Construction Parking and Access Strategy

North Strathfield for Sydney Metro West

CLNK-SYNC-CPAS-NST

Project Name	Sydney Metro West Stage 1 Phase J - North Strathfield Enabling Works
Planning Approval	SSI-10038
Document Title	Construction Parking and Access Strategy
TB Document no.	SMWSDDS-SYS-NST-TF-PLN-000009

Figure 1 Existing conditions and parking survey areas for North Strathfield

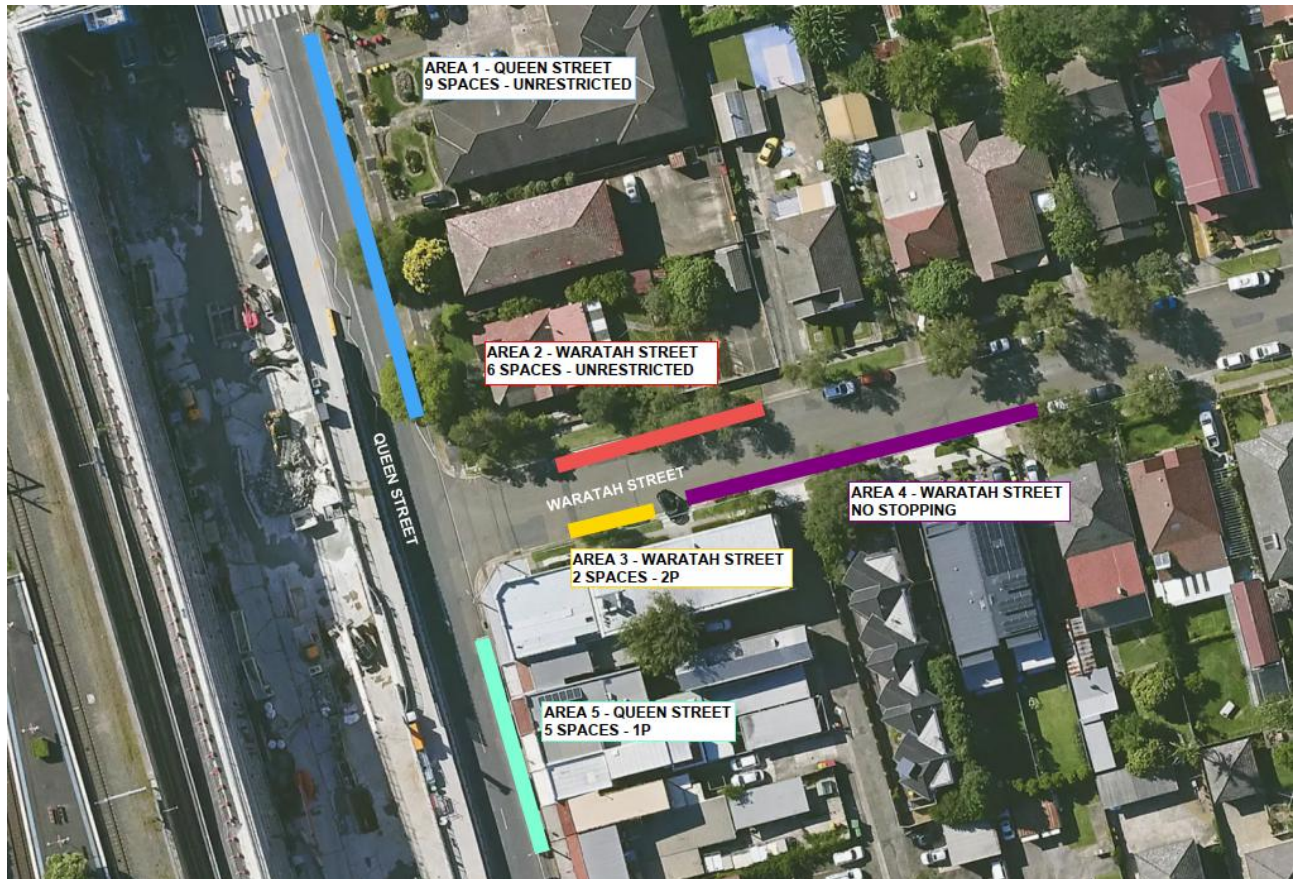
23	Public	No	08.01	2025-10-29	01	RVW	Adrian Washington	Syscon	This now has a reference to Area 3 as shown in Figure 1, in relation to the parking survey.	SMWSDD5-SYS-NST-TF-PLN-000009	Section 3	N/A	Observation	Y
24	Public	No	08	2025-10-15	01	RVW	Richard Banzon	Sydney Metro	Consider adding a figure that identifies the section on Waratah Street where parking spaces are proposed to be temporarily removed.	SMWSDD5-SYS-NST-TF-PLN-000009	Section 3	N/A	Observation	Y
25	Public	No	07.01	2025-10-29	01	RVW	Adrian Washington	Syscon	This has been updated.	SMWSDD5-SYS-NST-TF-PLN-000009	Section 1.2 Table 1	N/A	Actual Non-Compliance	Y
26	Public	No	07	2025-10-15	01	RVW	Richard Banzon	Sydney Metro	As per ER comments, this table needs to be revised with the correct SSI and MCoA. This project falls under the Stage 1 EIS, not Stage 3.	SMWSDD5-SYS-NST-TF-PLN-000009	Section 1.2 Table 1	N/A	Actual Non-Compliance	Y
27	Public	No	06.01	2025-10-29	01	RVW	Adrian Washington	Syscon	This has been added.	SMWSDD5-SYS-NST-TF-PLN-000009	Section 1.2	N/A	Observation	Y
